Access Compliance Report Public Rights-of-Way (Pedestrian Signals)

Intersection ID: N/A	Main Street:	Cross Street: N/A	Location: N/A
ADA ID: 938F932D8E58	Signal Type: One Push Button-APS	Overall Compliance: No	Severity Score: BTN 1: N/A BTN 2: N/A No BTN: N/A
Codes/Mitigation Info/Possible Solution		Field Measurements/Component Compliance

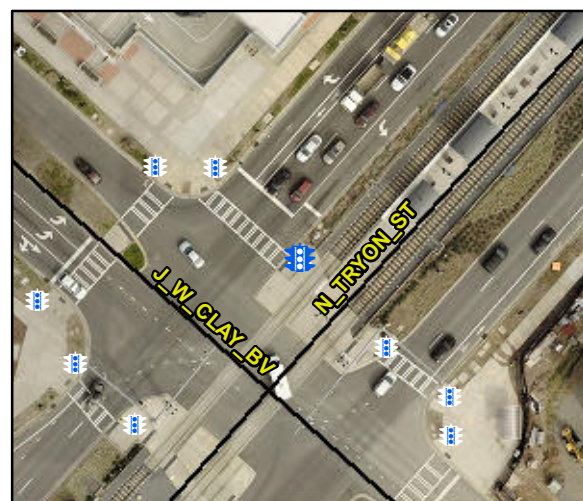
Possible Solutions: Replace Signal Push Button With APS Button on New Post. Remove & Relocate Sign.

PROW/ADA: TMUTCD 4e.08, R404.7.3, R404.7.2, R209.1, MUTCD 4e.10
